**From:** [Linda Candler](#)  
**To:** [CityClerk](#)  
**Subject:** Citizen Comments for City Council Meeting Today  
**Date:** Thursday, December 12, 2024 9:26:03 AM  
**Attachments:** [We sent you safe versions of your files.msg](#)  
[Refuge clearing exhibits.pdf](#)

TALKING POINTS CITY COUNCIL 12/12/ 2024

## Cross-Section E-E

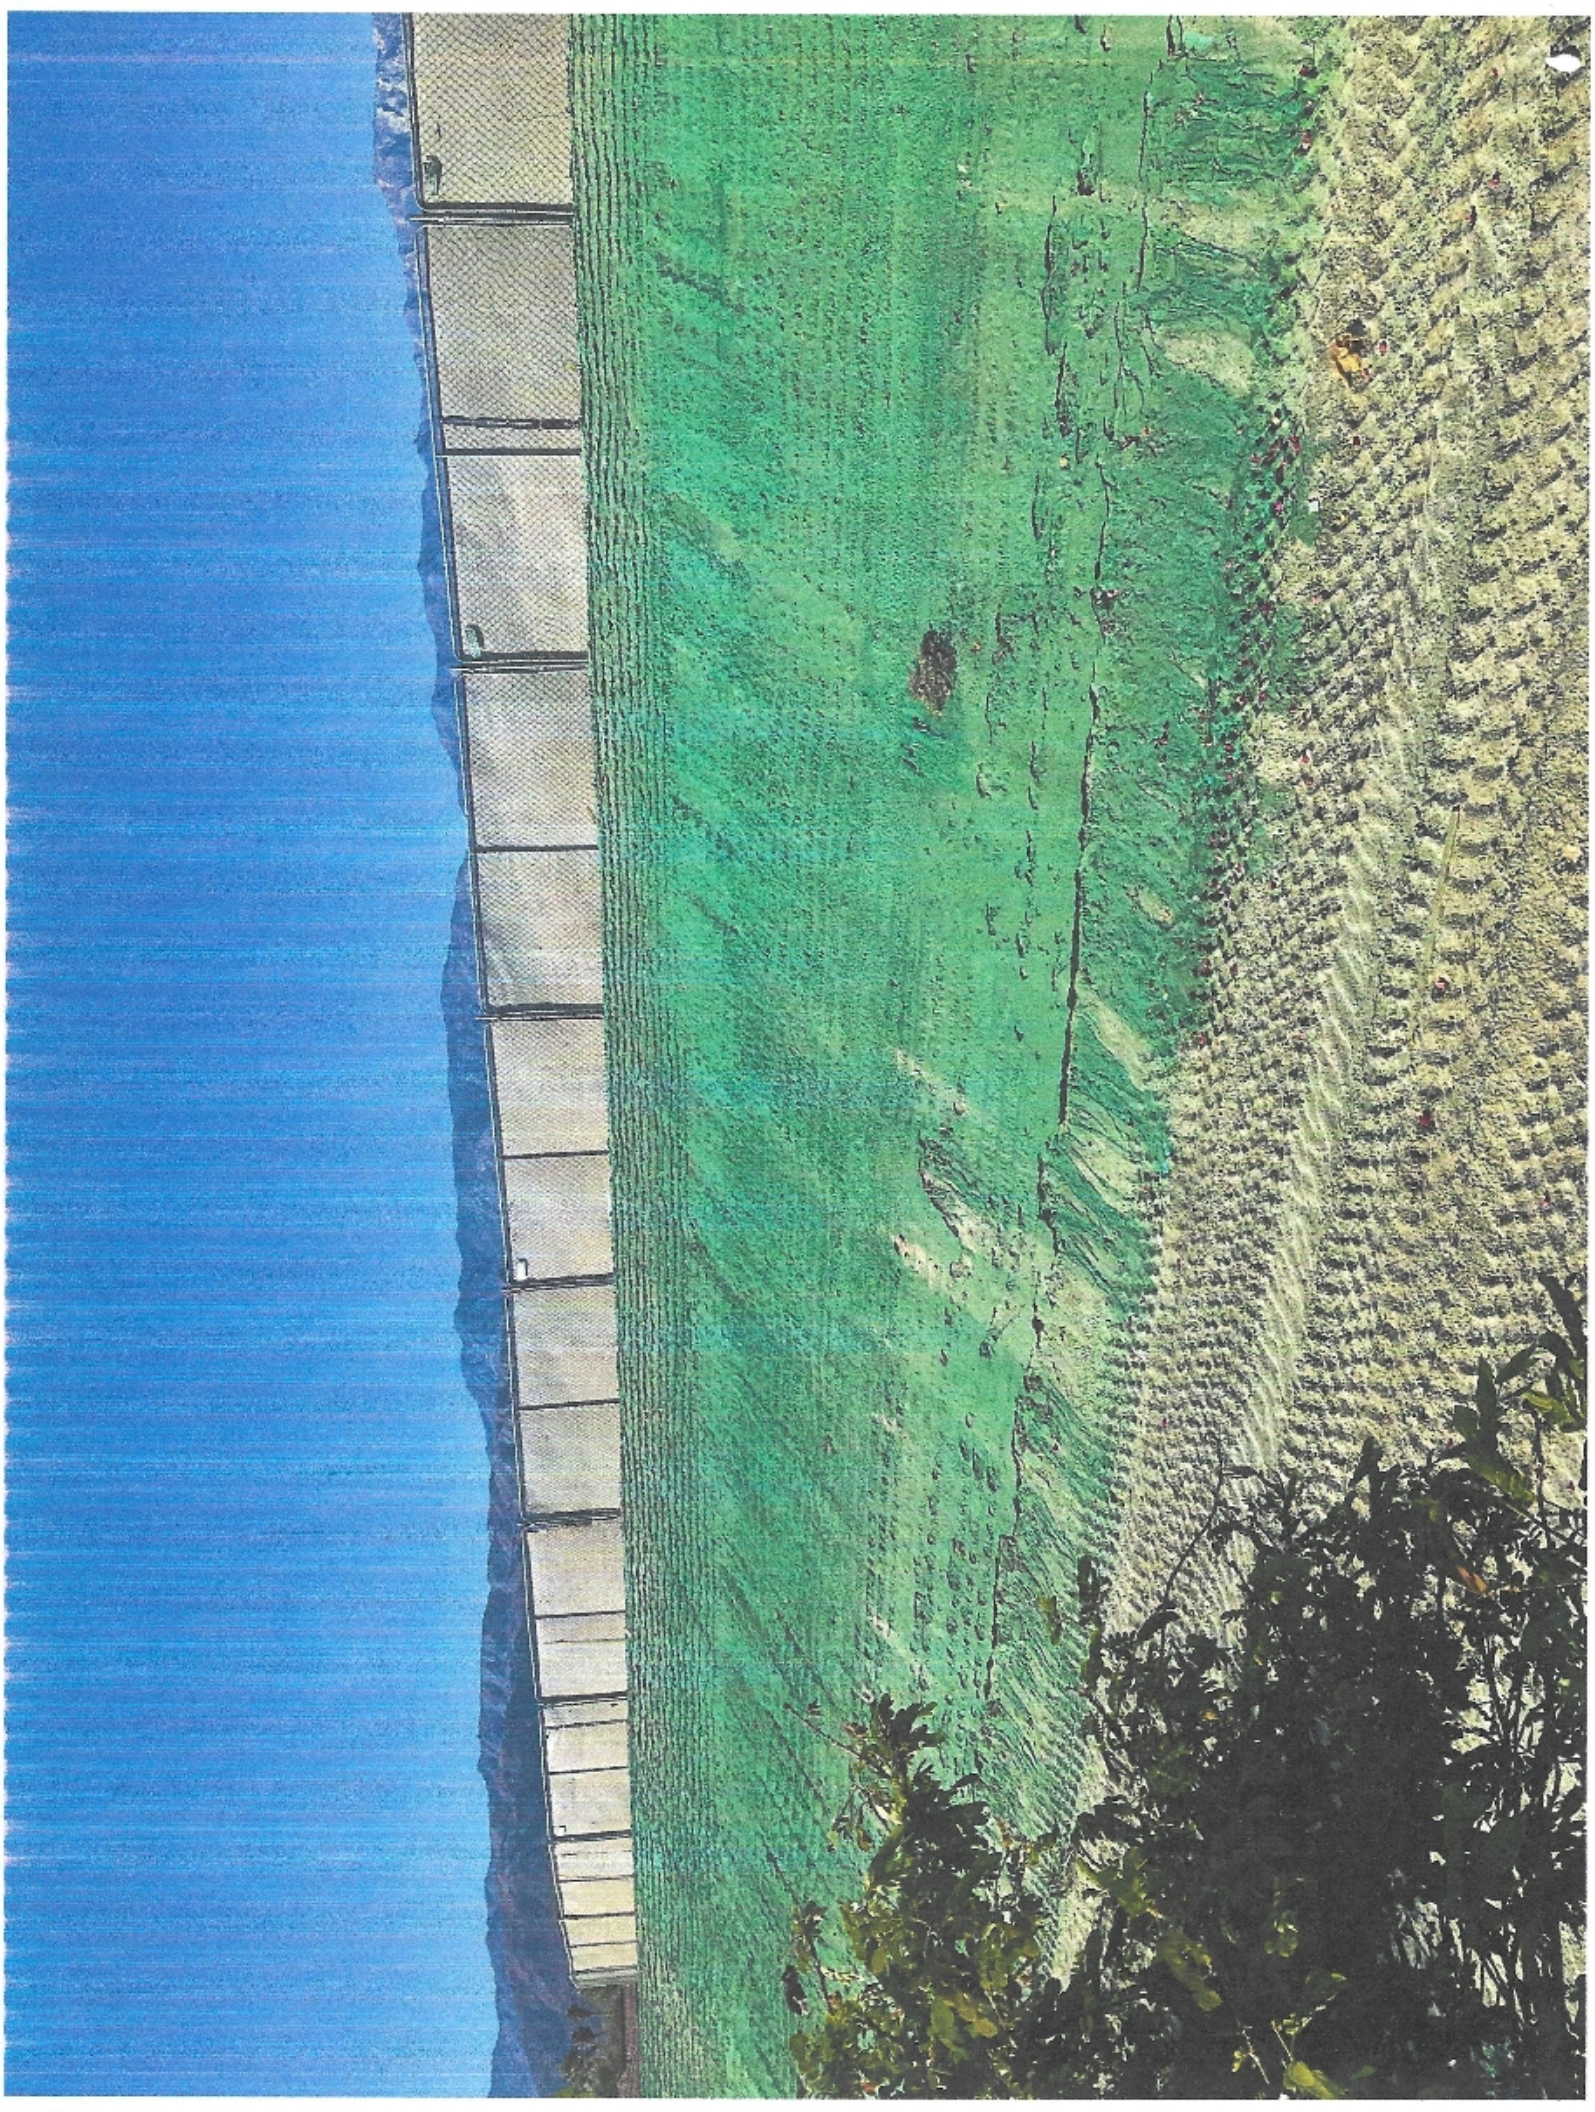
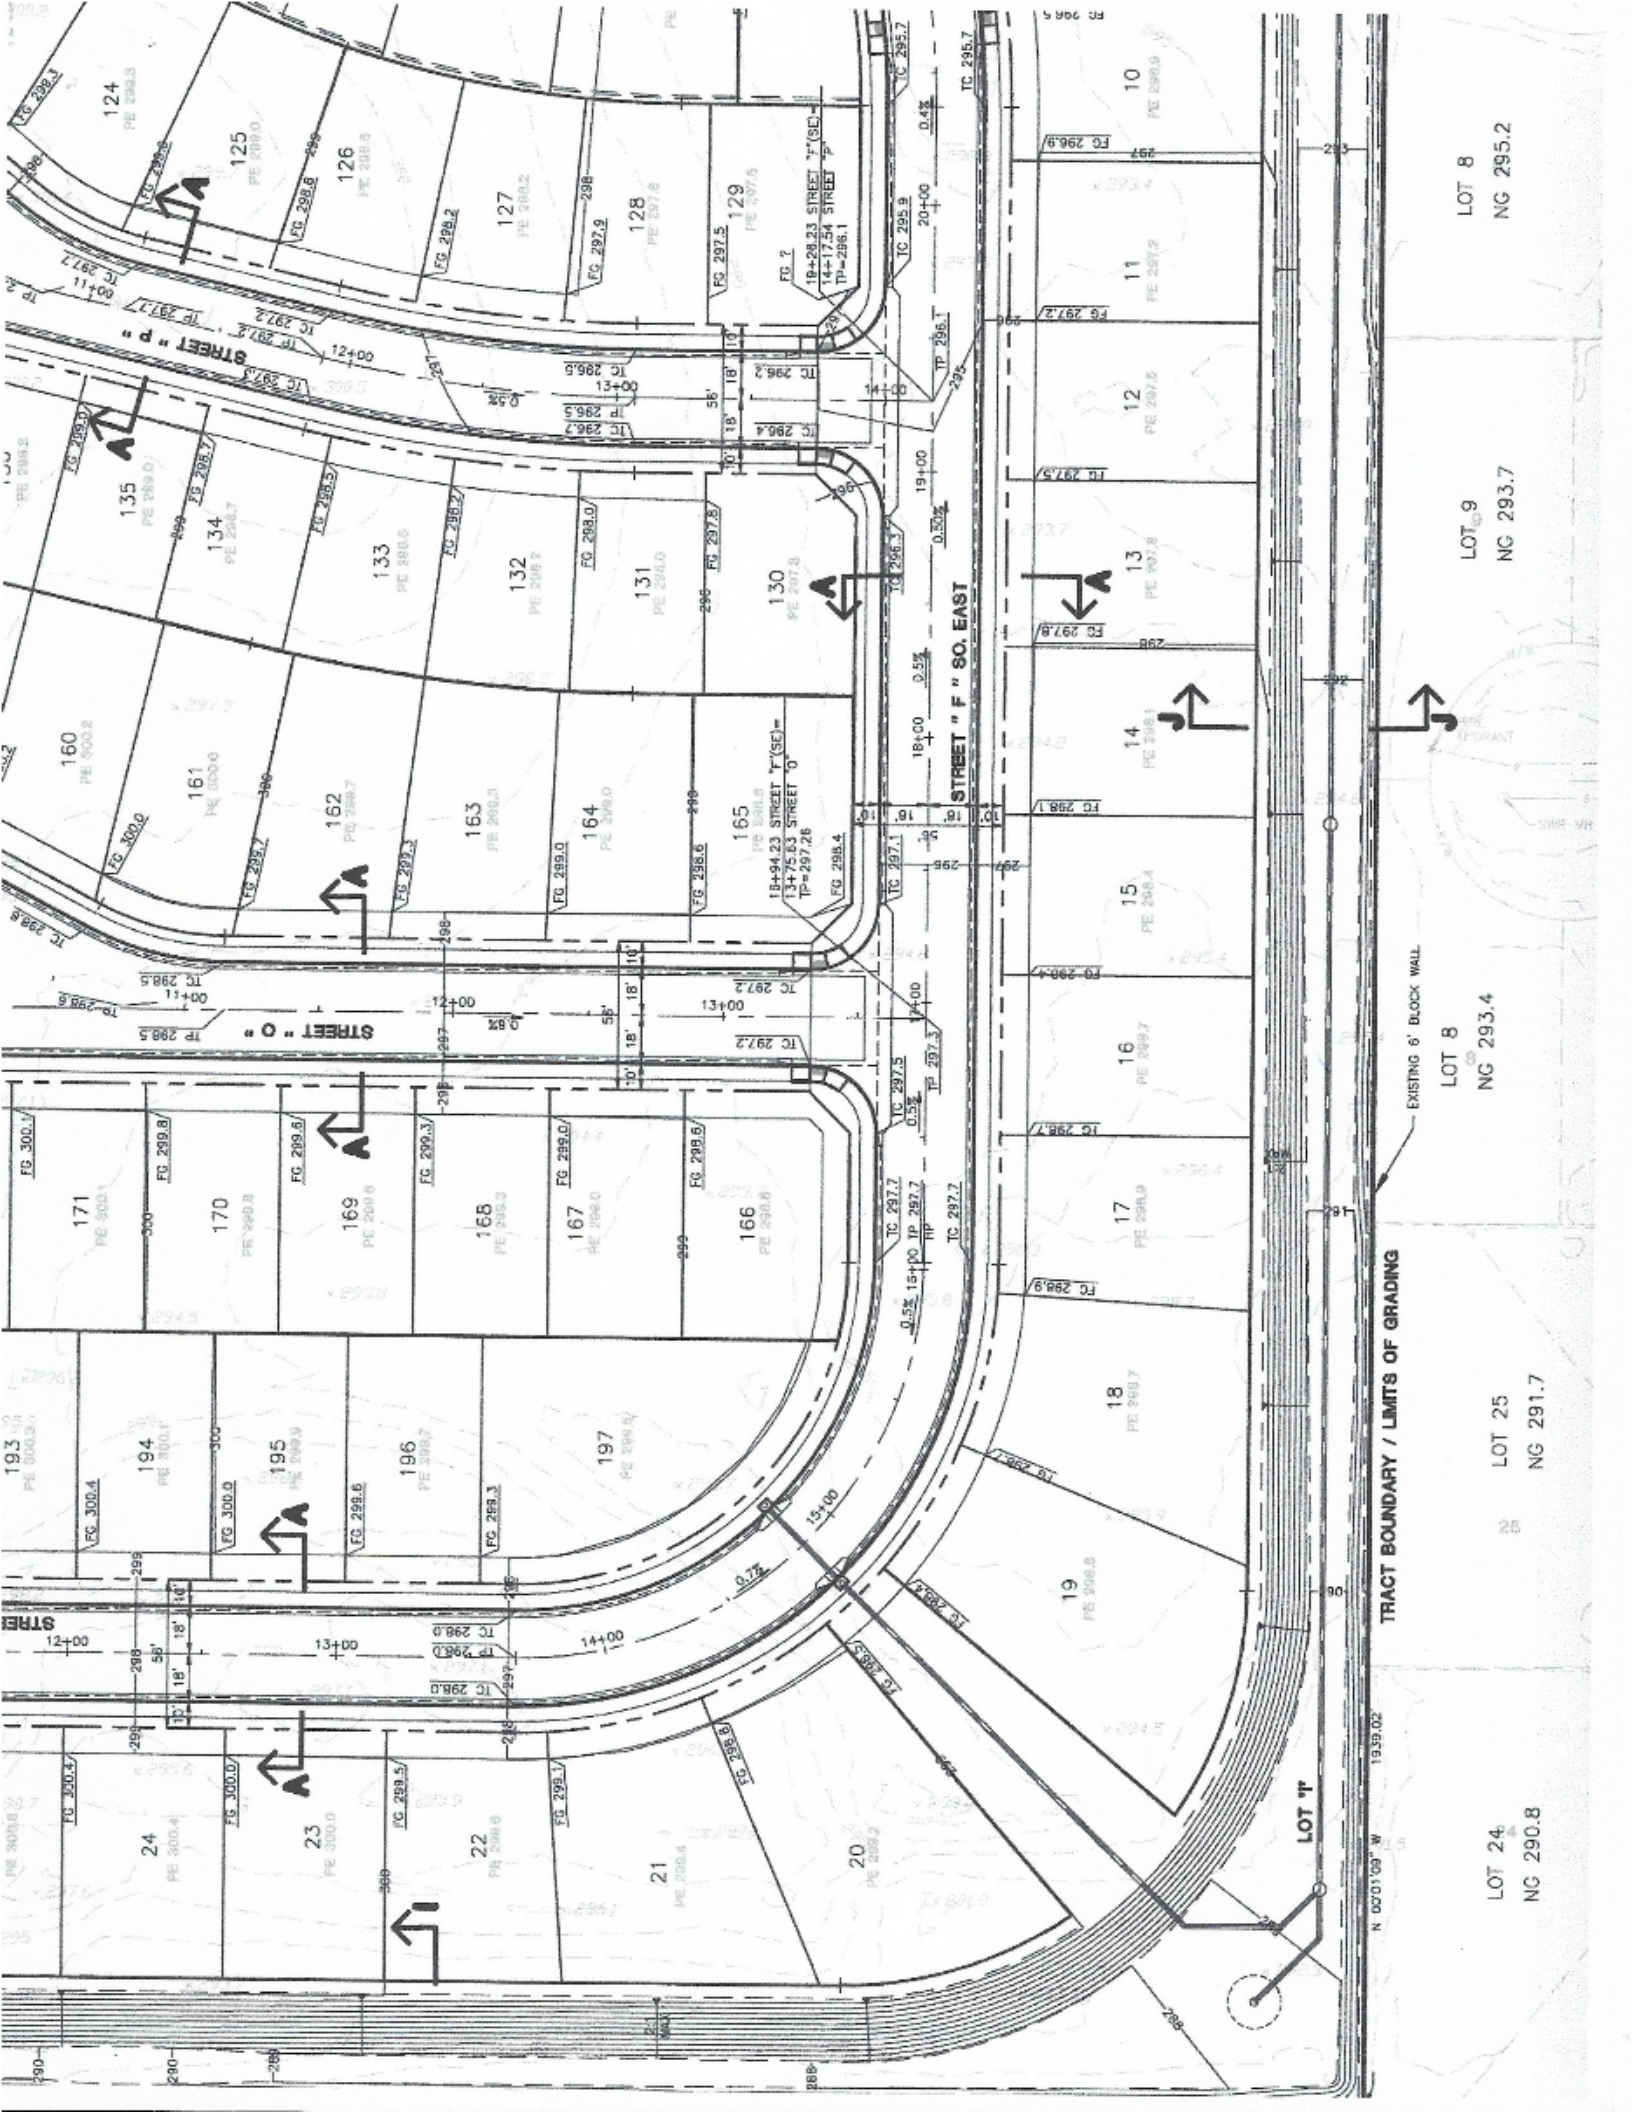
When the Rough Grading Plan was approved on March 5,2024 the Preliminary Grading Plan was changed. The change was significant as it moved the slope at least 10' closer to our back wall. This material information was not disclosed to us or to any adjacent homeowners. We were told by representatives of the Refuge that the only change to the Grading Plan was a 6" change to the pad height elevation. The Public Notice issued by the Planning Department and appearing in the Desert Sun also only referenced a 6" pad height change. The information about the change in the grading of the slope to create a large retention basin WAS NEVER DISCLOSED. This major change resulted in a slope at least 3' higher than what was originally portrayed in the Refuge Specific Plan approved in September 2022. I have previously submitted the Specific Plan exhibit showing the slope at 14' (based on a 7' pad height elevation gain) and ending at the back wall of the new homes. (copy attached). The slope is now more than 17' and it starts 22' from our back wall instead of 36' as specified in the original approved plans. This is due to the creation of a large retention basin and a large 5-10' flat shelf at the top of the slope.

In submitting the Rough Grading Plan and the Landscape Plan, Pulte and the City concealed from us a reduction to the buffer zone from 50' to 45'. This is another significant and material fact that was not disclosed to us by either Pulte or the Planning Department. We were told that the March 5, 2024 hearing to approve the Rough Grading Plan only related to a 6" change to the pad height. When we objected to a reduction in the buffer zone at the Landscape Hearing on May 21, 2024, the Planning Commission was told that the Rough Grading plan only changed the paid height by 6" and that there was not a 7' elevation gain. This information was misleading and incorrect.

We also request that the slope be regraded to eliminate the 5-10' flat shelf at the top of the slope. This was not per the Specific Plan. Regrading would lessen the steepness of the slope, which would reduce dust and risk of flooding.

Our final concern is with the drainage. As shown in the attached excerpts from the Rough Grading Plan, there are drainage pipes that run from the streets of the Refuge (Explore) site to the retention basin in the buffer zone behind our house. This is contrary to the representations made by Pulte that the pad height elevation was necessary to drain all water to the north end of the project, not the Southeast corner. (Lot 1). It is also contrary to repeated assurances that no water from the project drains to the buffer zone. The Southeast corner is a low point and we want the City to ensure that the water from the streets of the new development does not drain to the buffer zone at Lot 1.
